UNITED STATES  
NUCLEAR REGULATORY COMMISSION  
WASHINGTON, D. C. 20555

Amendment No. 57  
License No. DPR-32

Amendment No. 56  
License No. DPR-37

ATTACHMENT TO LICENSE AMENDMENT NOS. 57 AND 56

TS FIG 3.1-1

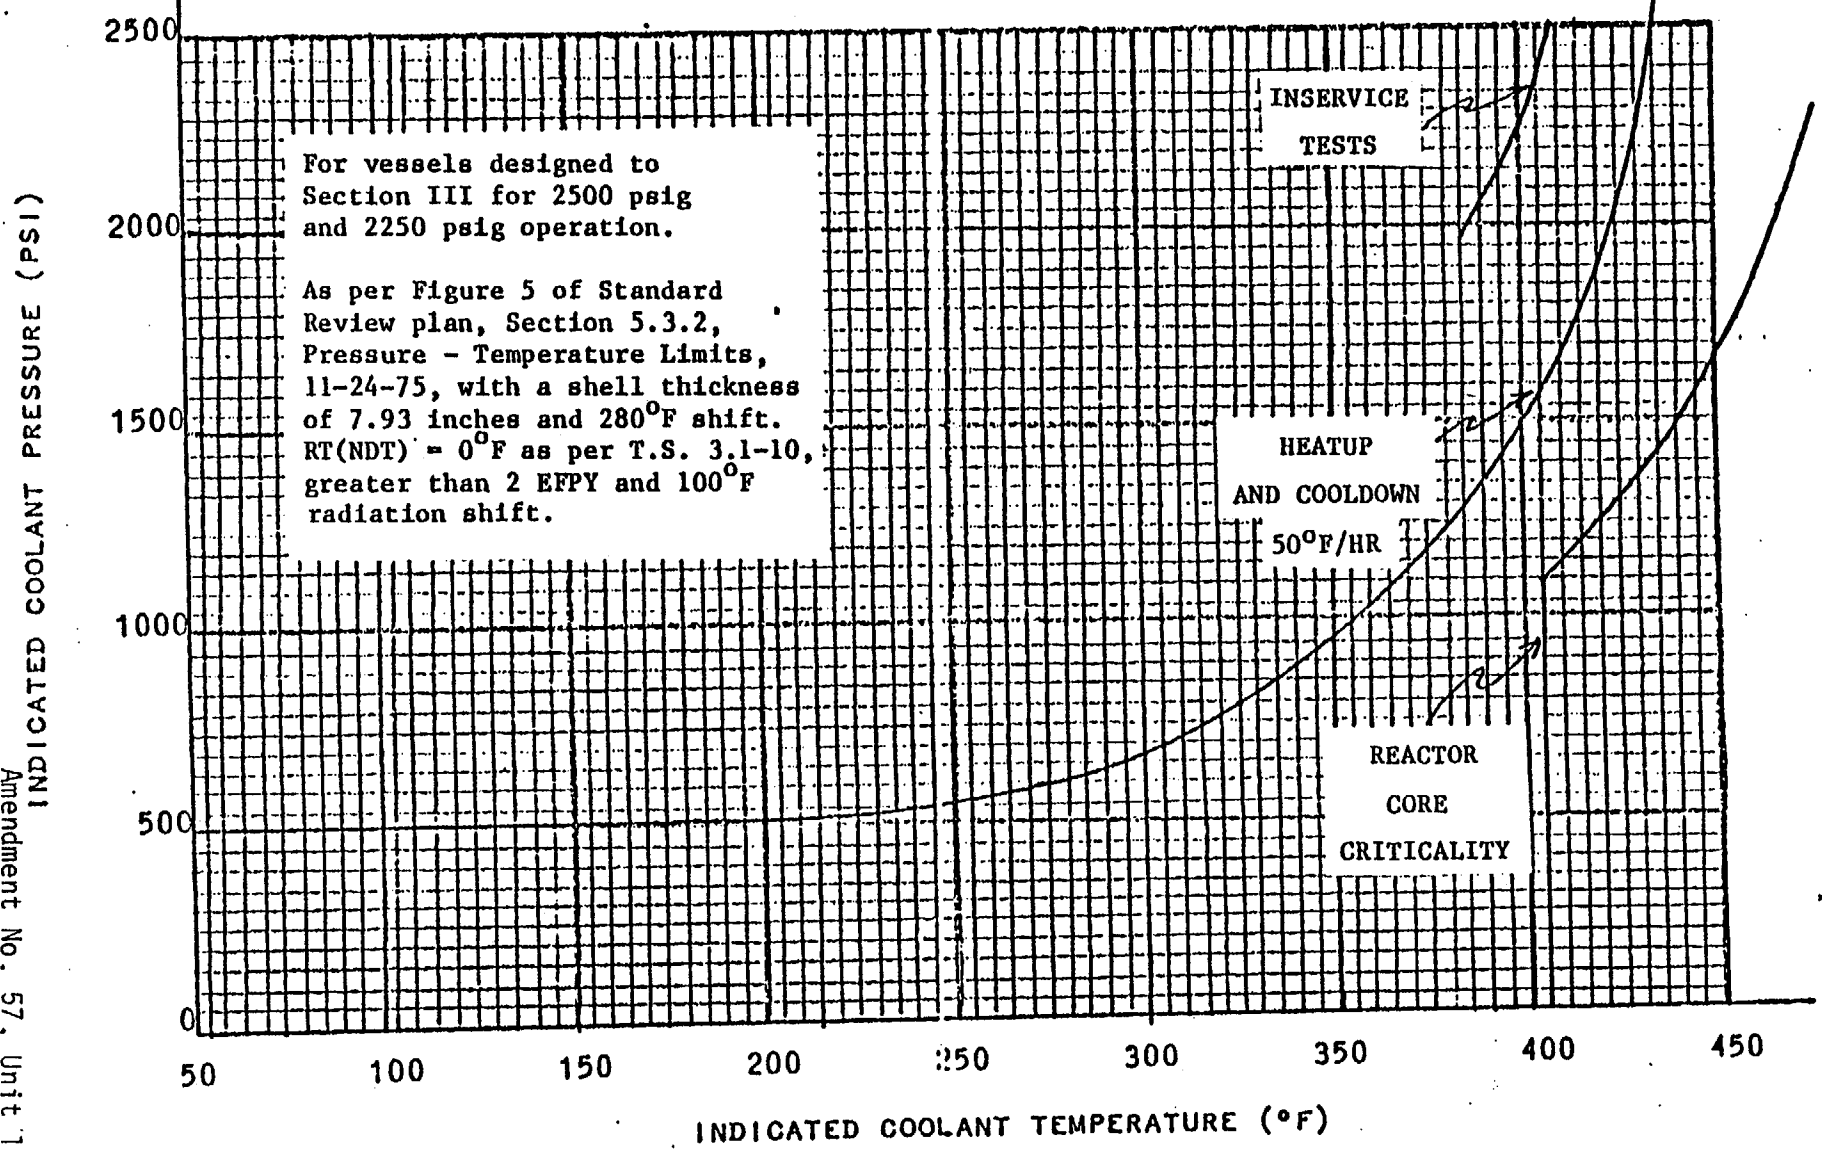
4. TS Figure 3.1-1 shall be updated periodically in accordance with the following procedures, before the calculated maximum exposure of the vessel exceeds the exposure for which TS Figure 3.1-1 applies. The curve based on 0.25% Cu weld in TS Figure 3.1-2 shall be used to predict the increase in transition temperature based on integrated power.

- c. The limit lines in TS Figure 3.1-1 shall be moved parallel to the temperature axis (horizontally) in the direction of increasing temperature a distance equivalent to the transition temperature increase obtained from TS Figure 3.1-2, less the increment used for the end of the present period.

TS Figure 3.1-1 defines stress limitations only. For normal operation other inherent plant characteristics, e.g., pump parameter and pressurizer heater capacity, may limit the heatup and cooldown rates that can be achieved over certain pressure ranges.

By letter dated December 15, 1978, Virginia Electric and Power Company (VEPCO) submitted an application to amend the Technical Specifications appended to Facility Operating Licenses DPR-32 and DPR-37 for Surry Units 1 and 2. The requested change would extend the acceptable operating period of the present operating limits from 3.8 EFPY to 11 EFPY.

The operating limits currently in the Technical Specifications are acceptable for operation to 3.8 EFPY. The same pressure-temperature operating limits are used for both Surry reactor vessels. The limits are based on the weld metal in the Surry 1 vessel which is the most limiting material. To date one material surveillance capsule has been removed from each vessel and tested. The test results on these capsules clearly show that the Unit 1 surveillance weld metal is the limiting material. However, this weld material is not identical to the weld metal used to fabricate the reactor vessel; i.e., these welds were not made from the same heats of weld wire and flux. Therefore, VEPCO recalculated the amount of radiation damage using damage prediction curves supplied by Westinghouse. This calculation showed that the present limit curves are acceptable through 32 EFPY.

Figure 3.1-2. Radiation Induced Increase In Transition Temperature

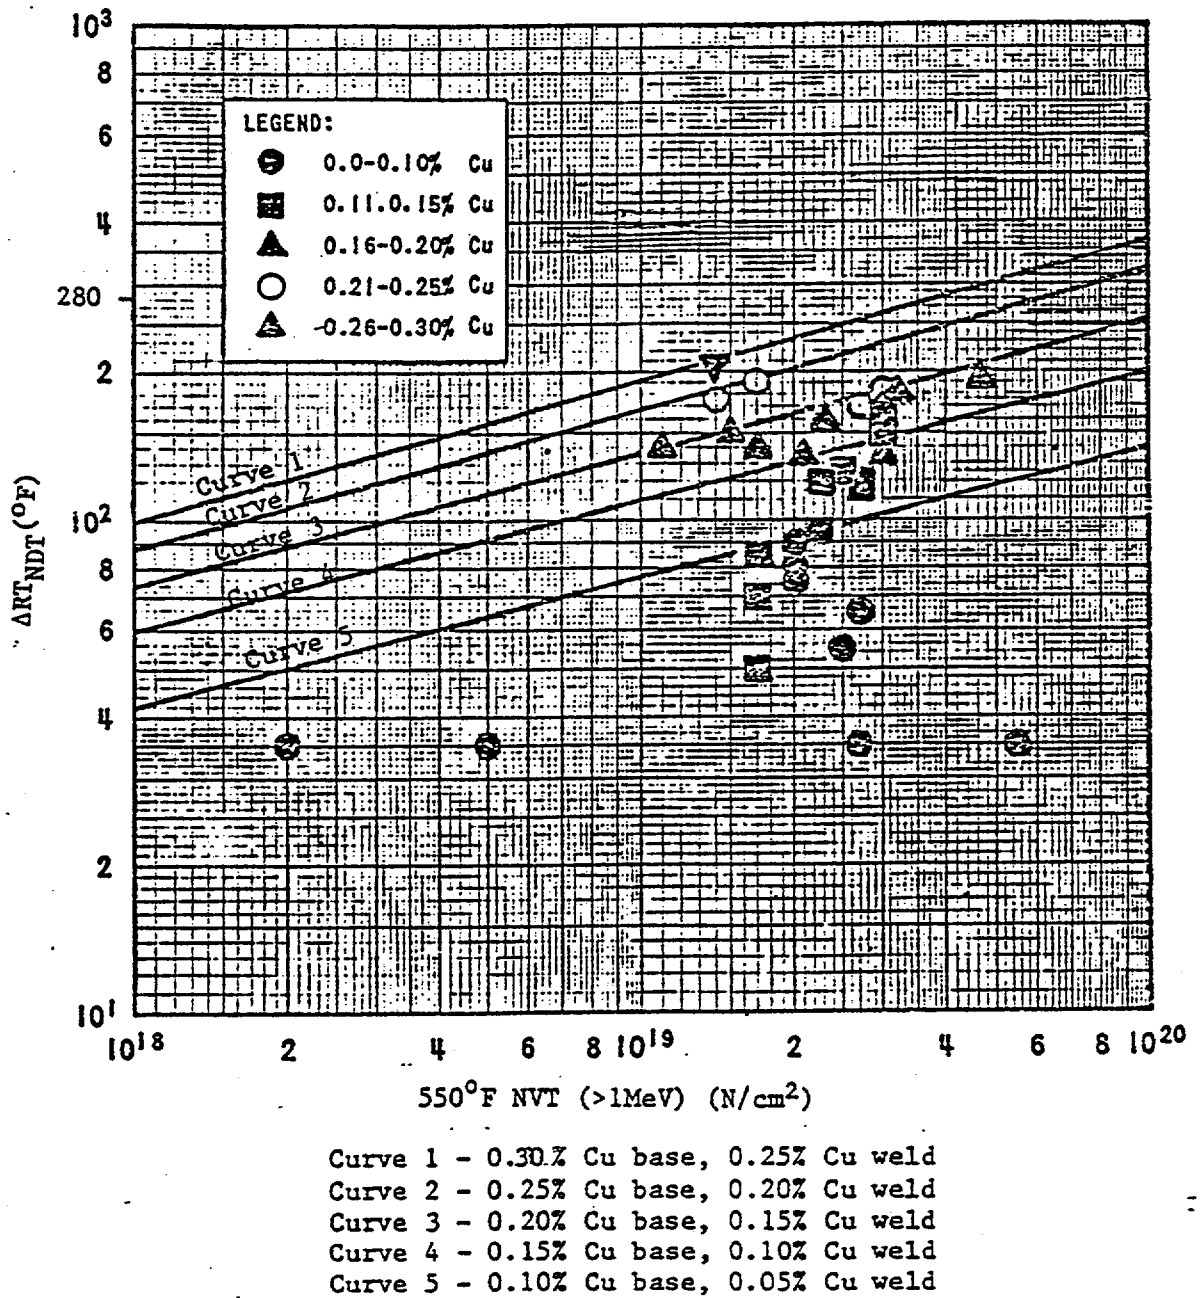
- b. At or before the end of the integrated power period for which TS Figure 3.1-1 applies, the limit lines on the figure shall be updated for a new integrated power period as follows. The total integrated reactor thermal power from startup to the end of the new period shall be converted to an equivalent integrated neutron exposure. The predicted increase in transition temperature at the end of the new period shall then be obtained from TS Figure 3.1-2.

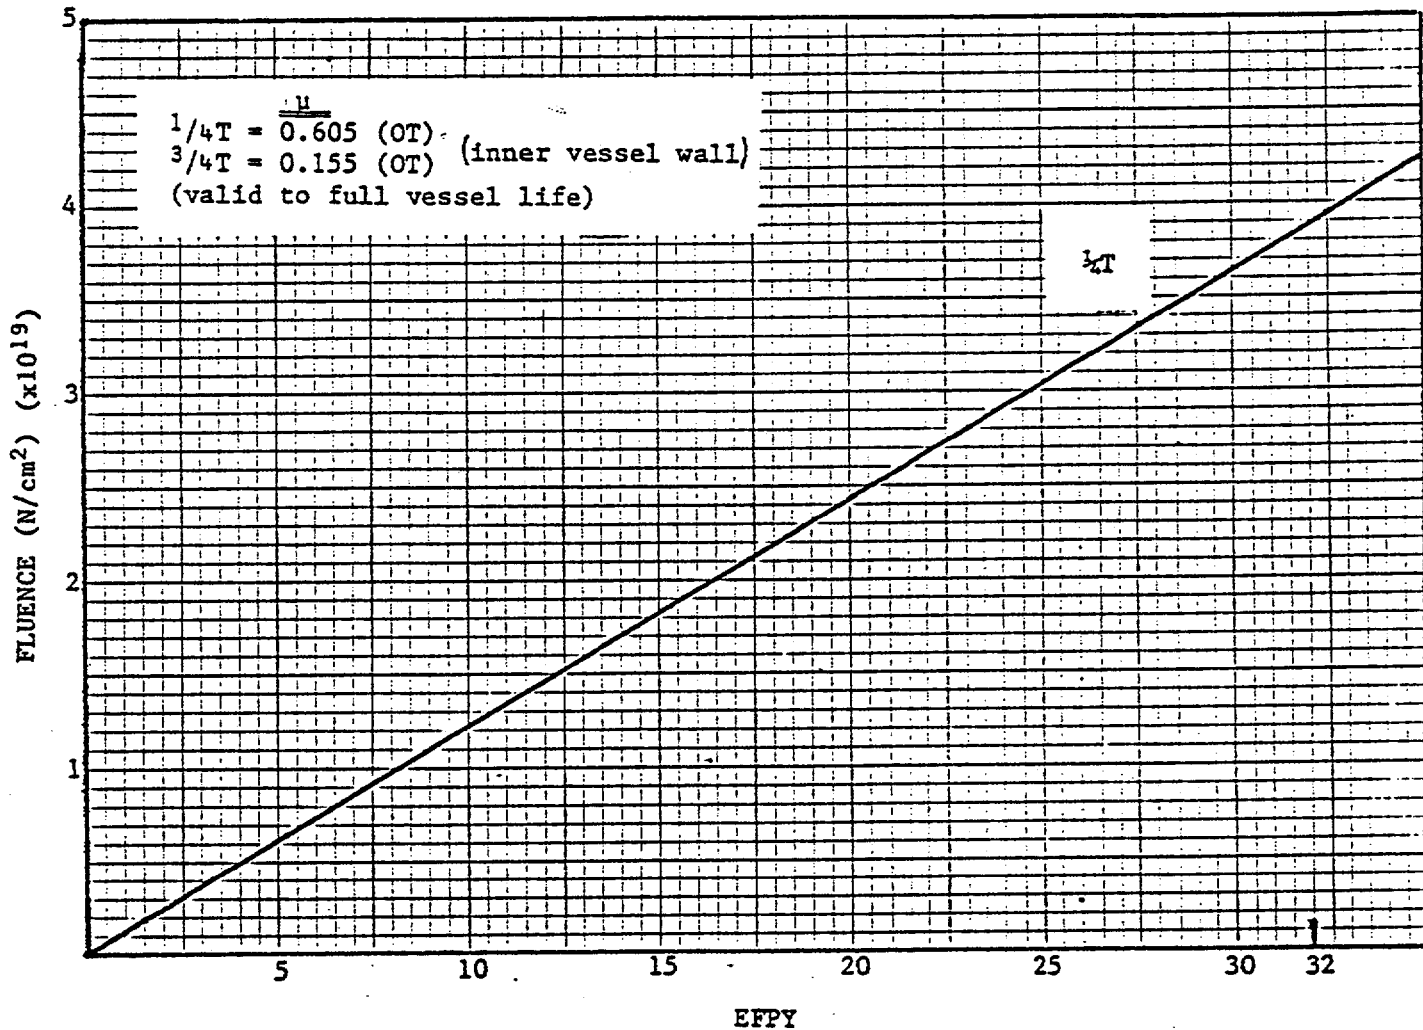
- a. If measurements on the most recently examined irradiation specimen show that its data point is above the 1/4T (thickness) line of T.S. Figure 3.1-3 then a new line shall be constructed through the origin such that it is above all the applicable data points. Once T.S. Figure 3.1-3 is revised, T.S. Figure 3.1-1 must be updated, either by a temperature shift, as by T.S. 3.1.B.4c below, or by revising the applicable period (EFPY) to match the new transition temperature from TS Figure 3.1-2.

NOTE: Slope of line ( $\phi$ ) above was determined from T.S. Figure 3.1-2 with a 0.25% Cu weld for 32 EFPY's and a 280°F shift as determined for T.S. Figure 3.1-1. It was calculated as follows:

$$\phi = \frac{3.85 \times 10^{19} \text{N/cm}^2}{32 \text{ EFPY}} = 1.203 \times 10^{18} \text{N}/(\text{cm}^2\text{-EFPY})$$
